# Access Compliance Report

## Public Rights-of-Way

### (Pedestrian Signals)

| ADA ID: 3471D1C4A258                    | Signal Type: One Push Button-APS | Overall Compliance: No                  | Severity Score: BTN 1: N/A BTN 2: N/A No BTN: N/A |

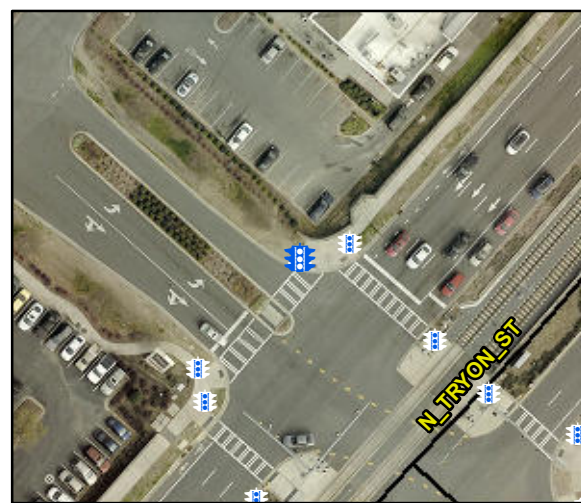
| Compliance | Description                             | Data    | Compliance | Description                            | Data         |
|------------|-----------------------------------------|---------|------------|----------------------------------------|--------------|
| No         | B 1 PARA Approach Reach (in)            | 12.0    | N/A        | B 2 PARA Approach Reach (in)           | N/A          |
| No         | B 1 PARA Approach Width (in)            | 48.0    | N/A        | B 2 PARA Approach Width (in)           | N/A          |
| No         | B 1 Clear Floor Space Slope (%)         | 6.2     | N/A        | B 2 Clear Floor Space Slope (%)        | N/A          |
| No         | B 1 Clear Floor Space XSlope (%)        | 3.0     | N/A        | B 2 Clear Floor Space XSlope (%)       | N/A          |

| No B 1 Verbal Walk Cycle?           | Yes | N/A B 2 Verbal Walk Cycle?          | N/A |

Possible Solutions: Remove & Replace  
Replace APS Button With New APS Button.  
Remove and Replace Clear Space.

PROW/ADA: R404.2, R404.3, R404.7.3,  
R404.7.2, R209.1, MUTCD 4e.10
